GROUP	MODEL
FUE	2022MY Carnival (KA4)
NUMBER	DATE
060 (Rev 1, 05/23/2025)	August 2022

TECHNICAL SERVICE BULLETIN

CYLINDER IMBALANCE DTC P219XX00 INSPECTION AND INJECTOR REPLACEMENT

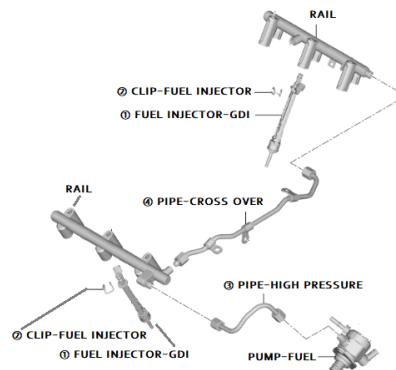
If one or more of the listed DTCs are present for any cylinder, then one or more high-pressure injectors (1) and clip (2) may require replacement if DTC is stored. In addition, replacement of the high-pressure fuel pipe (3) and cross-over pipe (4) will need to be replaced. Follow the procedure outlined in this publication to inspect the ECU for DTCs and if necessary, replace required parts described in this publication.

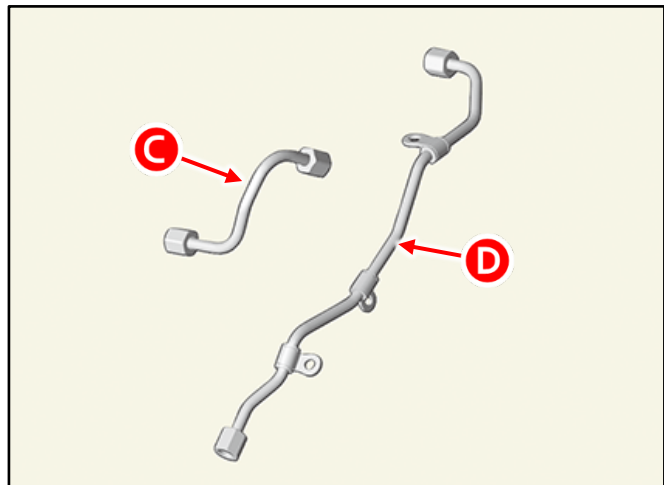
The 'new' injectors are supplied with new O-Rings (B).

DO NOT re-use the removed parts.
Replace the high-pressure pipe (C) and cross-over pipe (D) with new parts.
